Air Studios Lyndhurst Hall, Lyndhurst Road, Hampstead, London NW3 5NG

Structural and Ground Dynamics

Addendum Report Responding to comments by :-Alan Baxter Associates (ABA) and Cole Jarman (CJ)

Ref: AKS/3400/R1/i1/Addendum Report

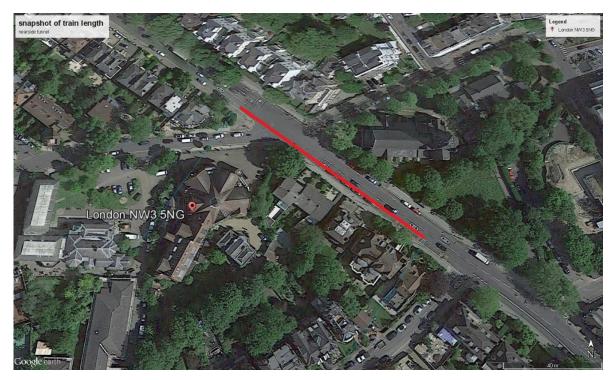
CED state that the basement structures may provide a more efficient transmission of ground borne noise and vibration. We do not agree that this is a possibility, based on the configuration and disposition of the new structures and the longer sound path in the ground to them, than the direct sound path to the Hall.

It is not just about proximity, i.e. whilst obvious to think the closest source is the worst, it is a function also of the track condition, and the rolling stock condition as it traverses the track. Therefore, the worst event could arise with the train upstream or downstream of the closest point, and this track condition is not a fixed situation but a variable. Therefore, there can be a situation where dominant train sources arise in a position placed such that the zone of transmission encompasses and is modified entirely by the basement structures and associated piling.

The closest point of the Air Studios building to the tunnel does not necessarily dominate the groundborne noise within Air Studios, which is dependent upon dynamics of surfaces, which will have some parts more easily excited than others and so vulnerable to different energy paths. Therefore it is insufficient to place ones attention on what is superficially obvious, but such closer examination is more revealing.

If we take an overall train length of 108m for the rolling stock used in the Northern Line, and superimpose it on the site aerial view below (one snapshot shown), it should be immediately obvious that modifications in the energy paths, can alter the levels of groundborne noise within Air Studios, due to changes in the efficiency with which energy is transmitted to the Air Studios buildings and significantly the surfaces within that can radiate sound. It should be recognised that this is a moving window. It should also be recognised that the dominant path may well either now, or at some point in the future, due to track degradation, be the paths that runs between the extended source and via the new basements to Air Studios.

Using the mechanism stated by ABA that their sub structures will more efficiently absorb energy within it therefore can also bring energy to the surface and to Air Studios more efficiently.
